# North Dakota Department of Transportation

## ADDENDUM 1 – JOB 32

TO: All prospective bidders on project HRR-8-200(020)951, Job No. 32 scheduled for the April 10, 2015 bid opening.

Revised	3/31/15	STATE	PROJECT NO.	SECTION NO.	SHEET NO.
		ND	HRR-8-200(020)951	130	1

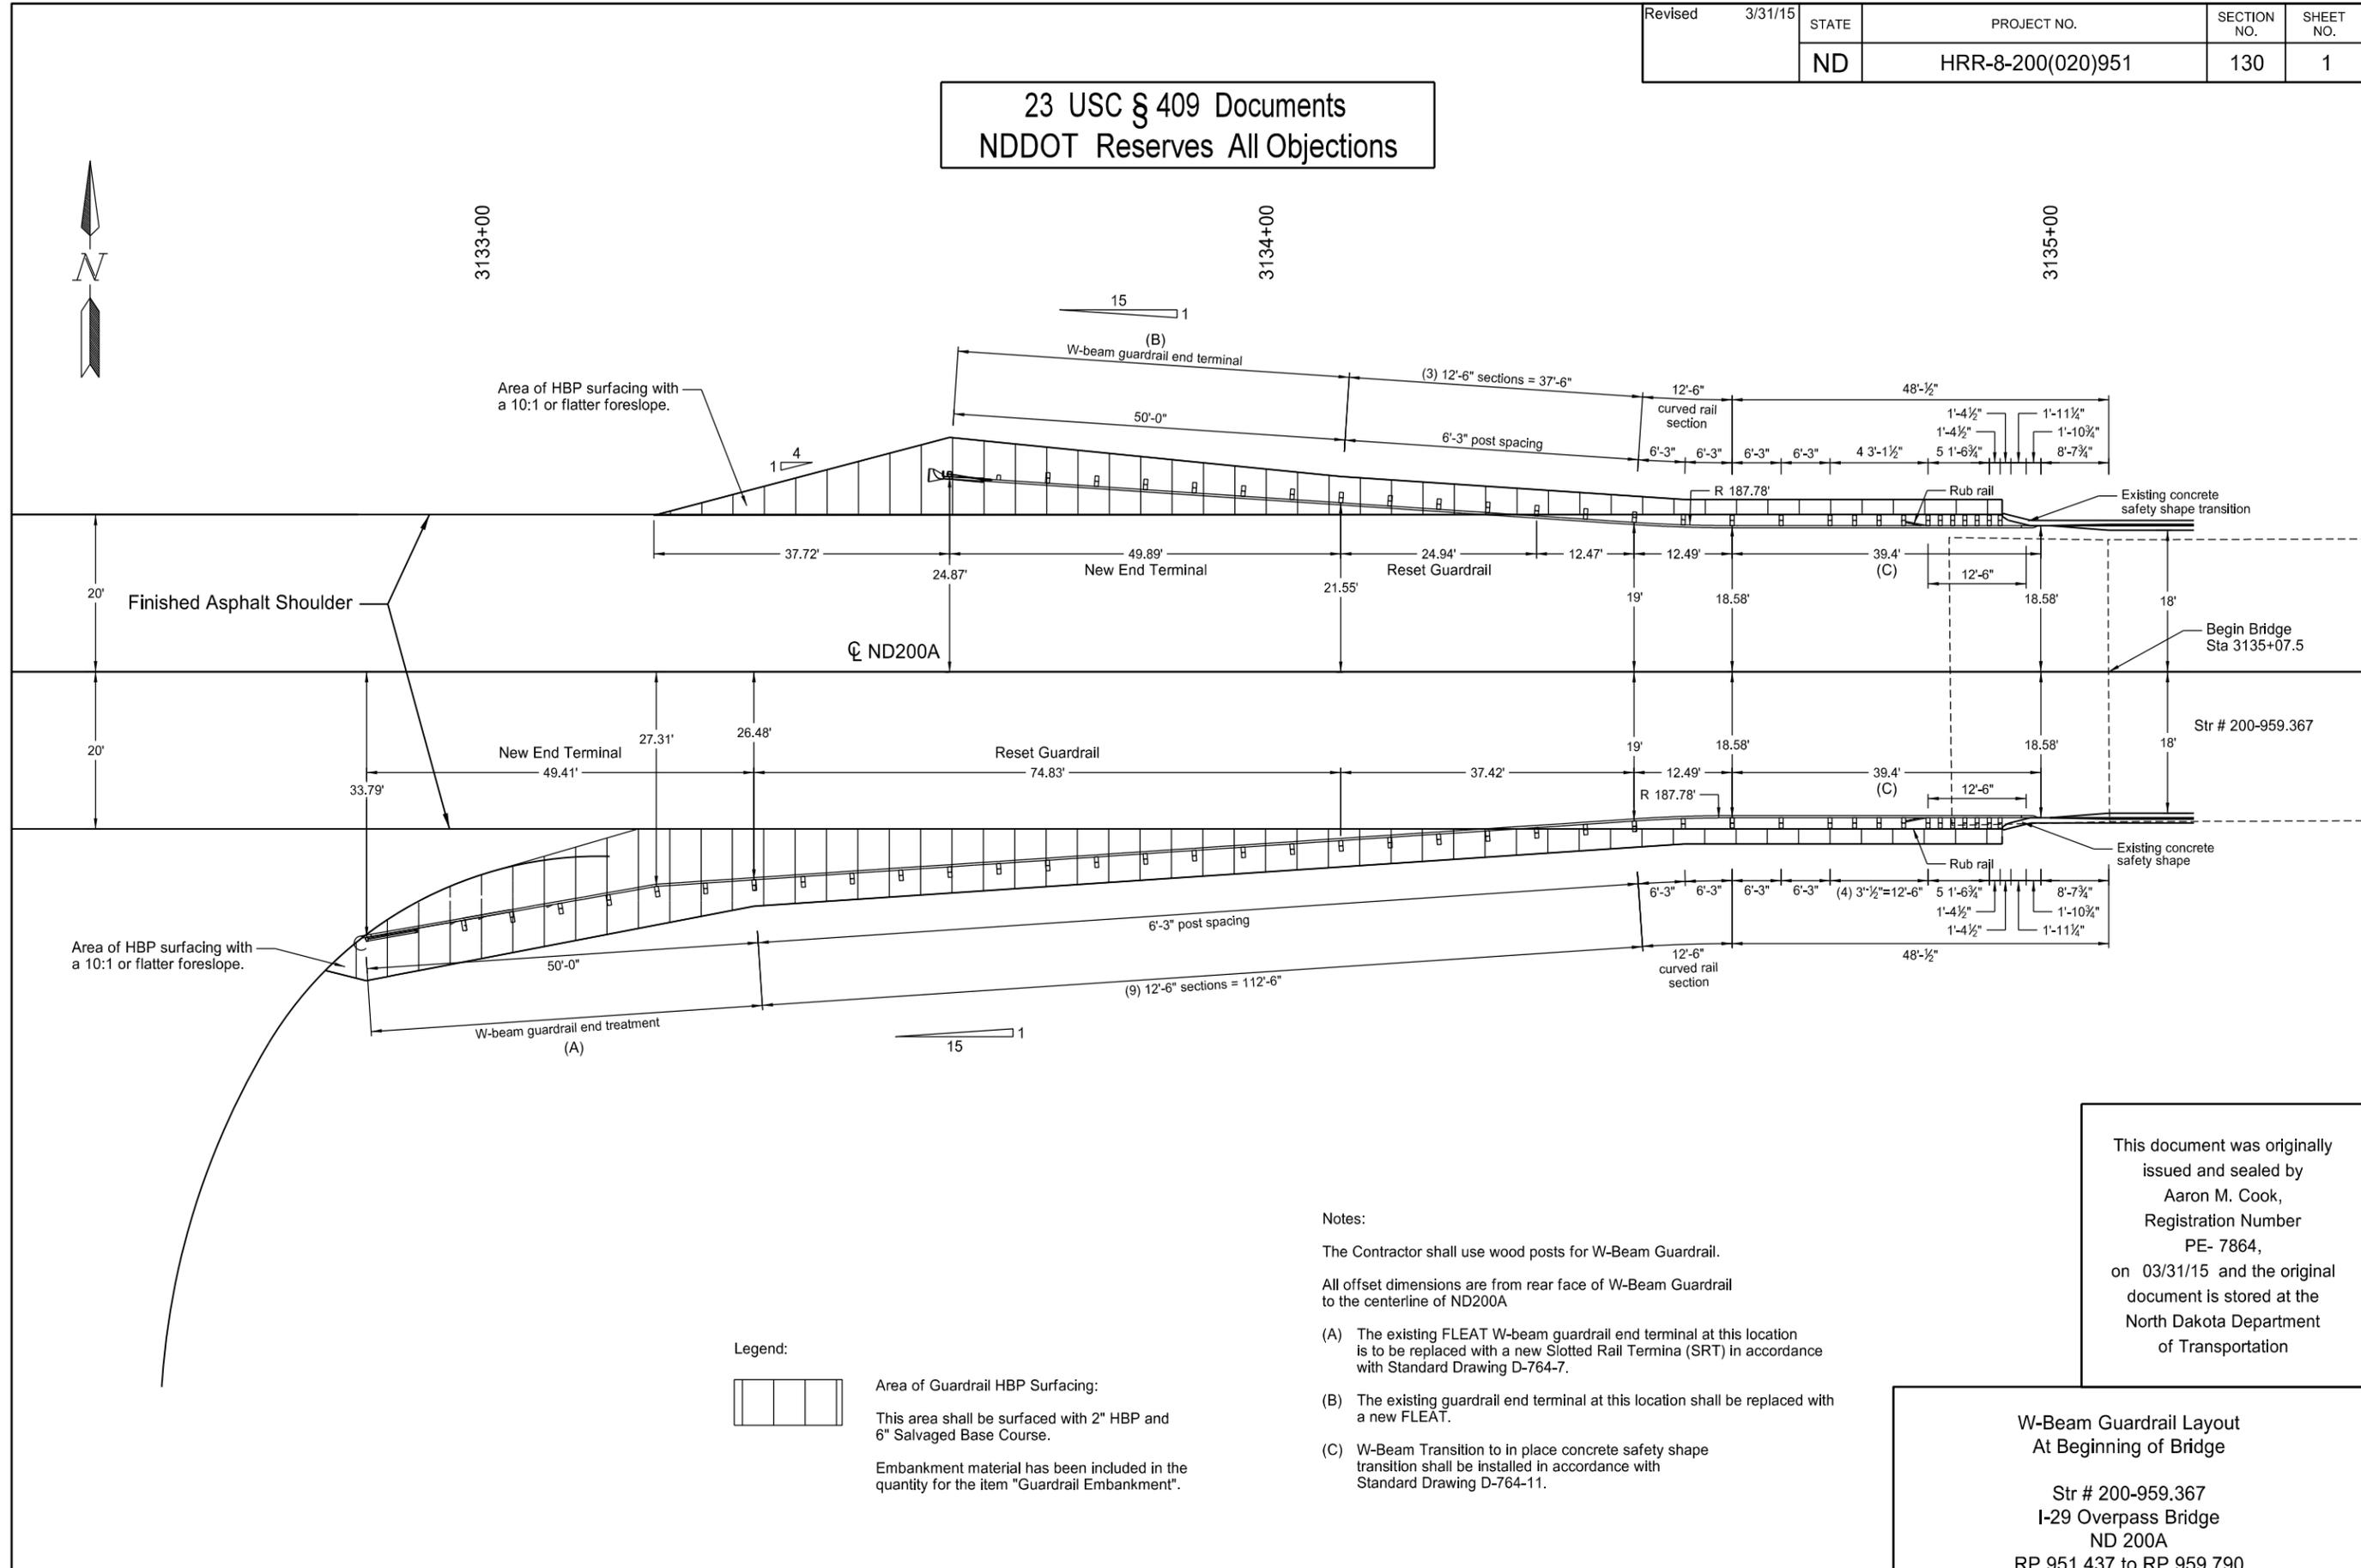
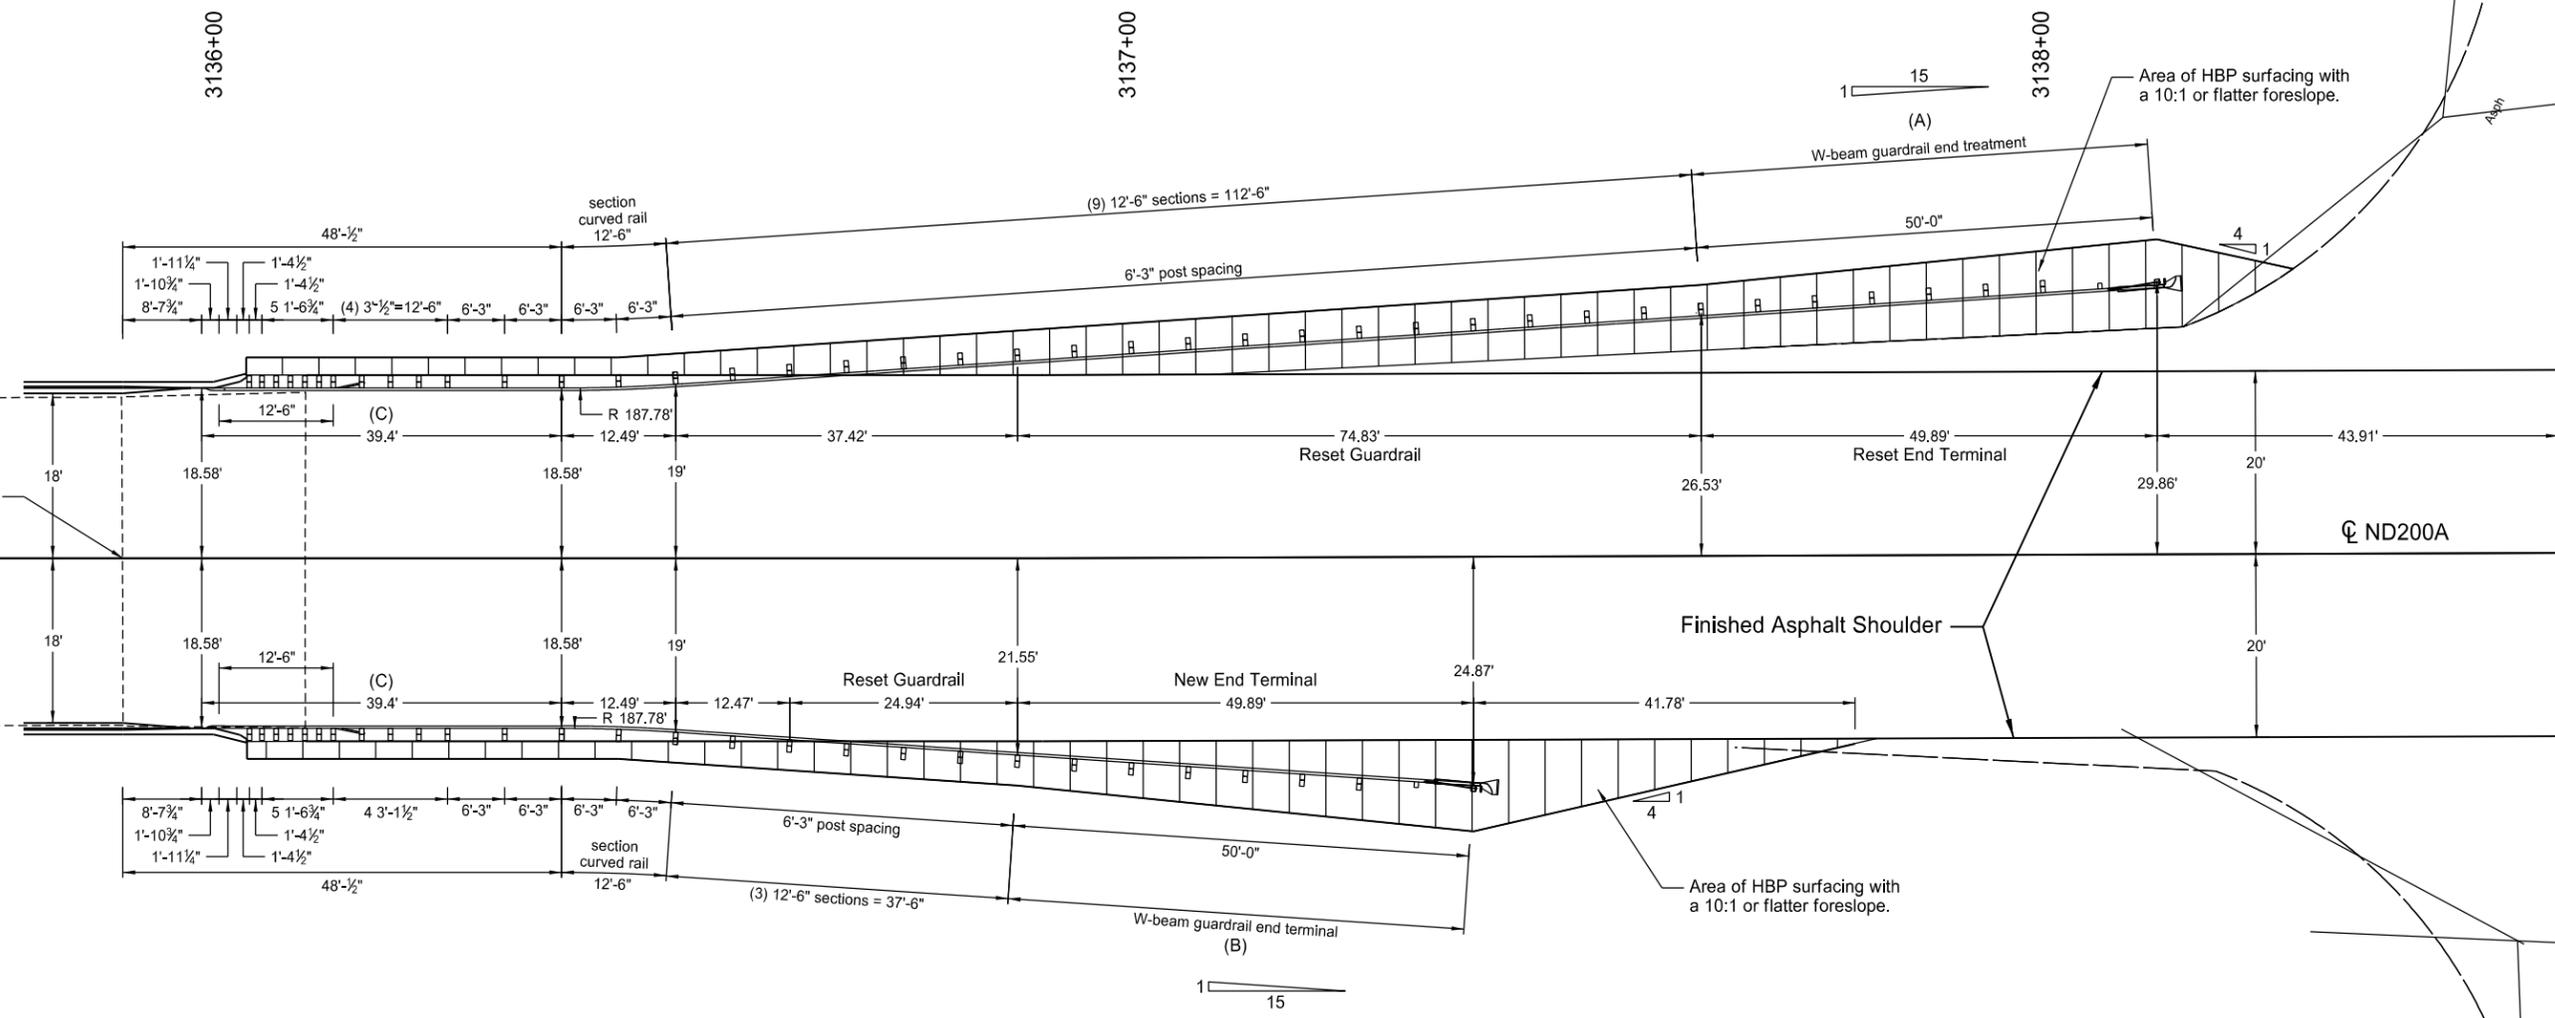
Revised Guardrail Notes.

Added labels for the guardrail and end terminals to be reset and dimension for the curved rail.

Revised	3/31/15	STATE	PROJECT NO.	SECTION NO.	SHEET NO.
		ND	HRR-8-200(020)951	130	3

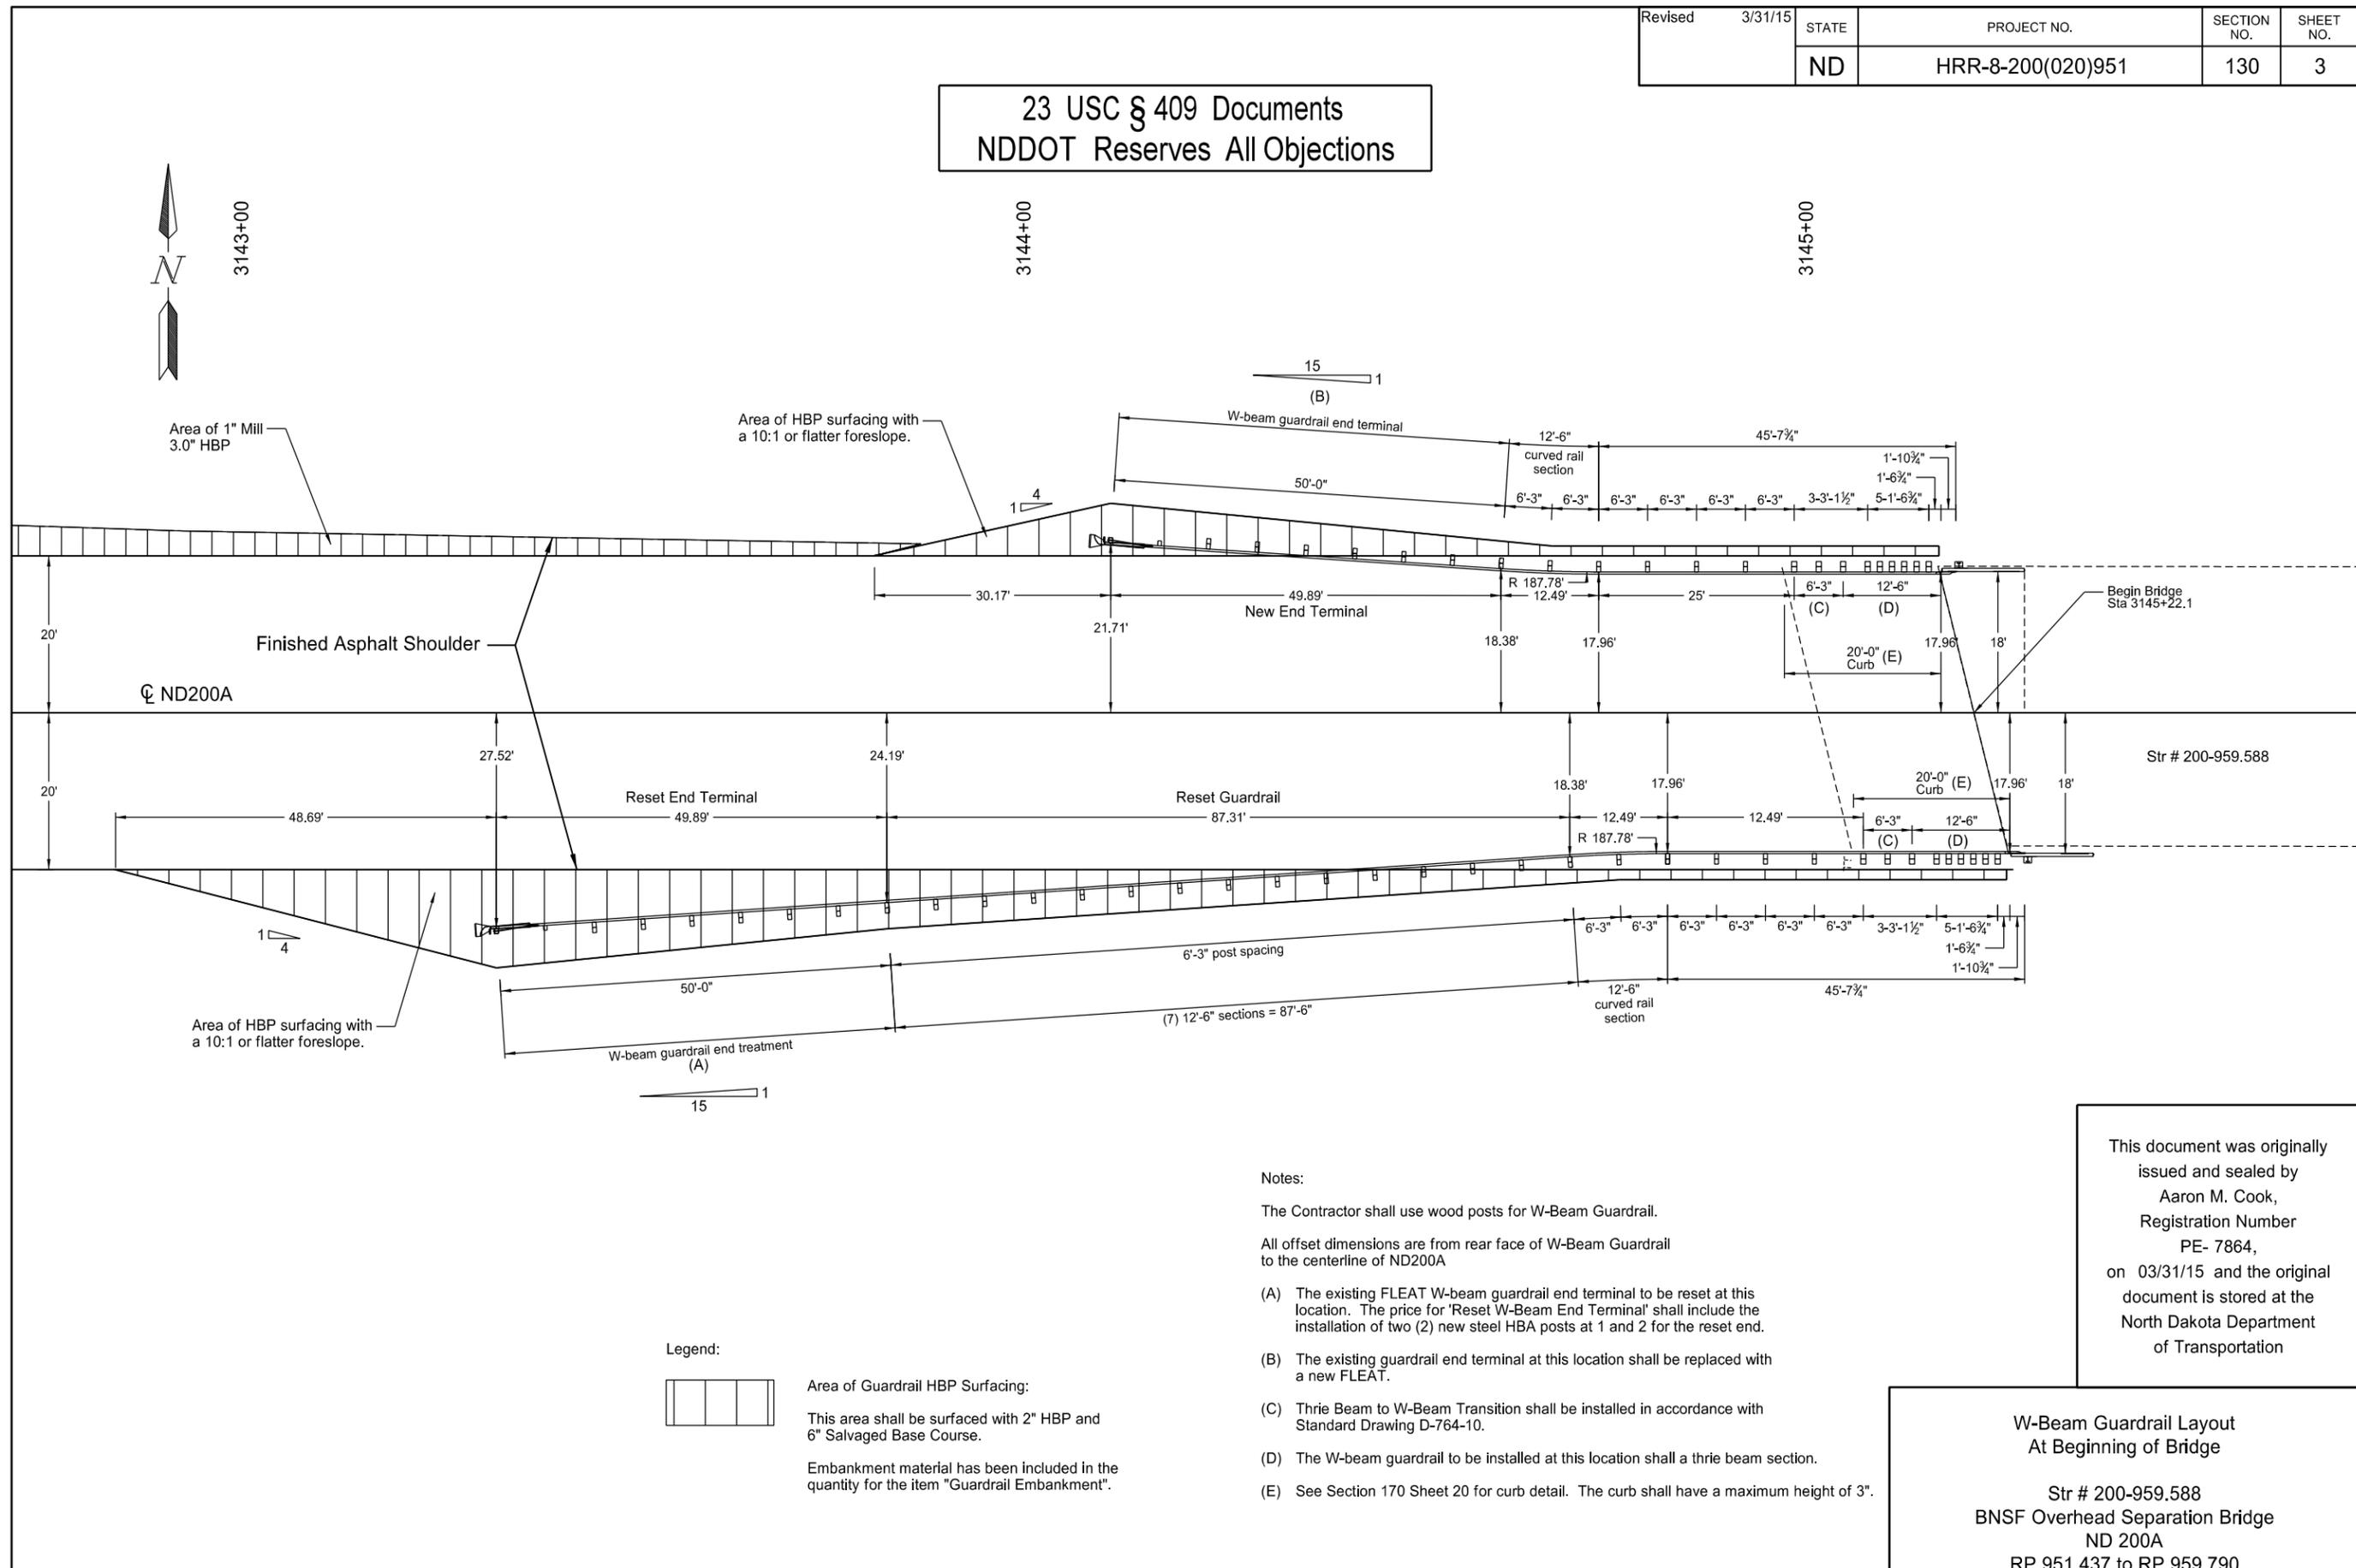
Revised Guardrail Notes.

Added labels for the guardrail and end terminals to be reset and dimension for the curved rail.

Offset dimensions were revised by 0.04' to reflect connection plate.
